GTS Newsletter

2009/15E

Machine	TASKI swingo XP
Subassembly	Brush Drive

Bevel gear and support with bearing

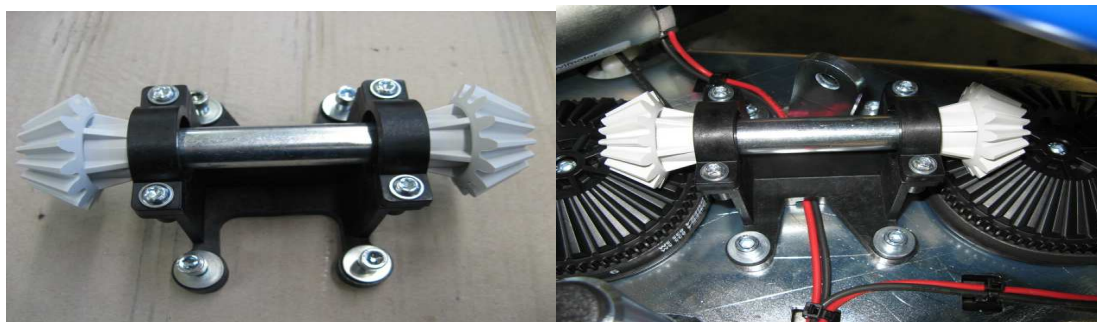
High spares consumption/wear of bevel gears, synchronization axles and belts of brush drives lead to a thorough examination of the whole brush unit set-up.

As a first step the material of the bevel gears has been adjusted to the operating conditions (material modification from black to grey). As a next improvement we are implementing a new support with bearing, which will be stabilising the whole synchronisation and hence limiting the above mentioned wear.

The new support with bearing will be delivered only complete. The material includes bevel gears, axle and support with bearing preassembled. This simplifies and quickens the mounting.

With immediate effect the new support with bearing is available as spare part. It is suitable for all series machines.

On the 0-series machines the distance between the brush drives is a little larger and therefore the following spare parts have to be used when carrying out a repair:

- 4129118 (18603-80) Support with bearing for 0-series machines
- 4124271 (18600-84) Axle
- 4123625 (18600-83) Bevel gear
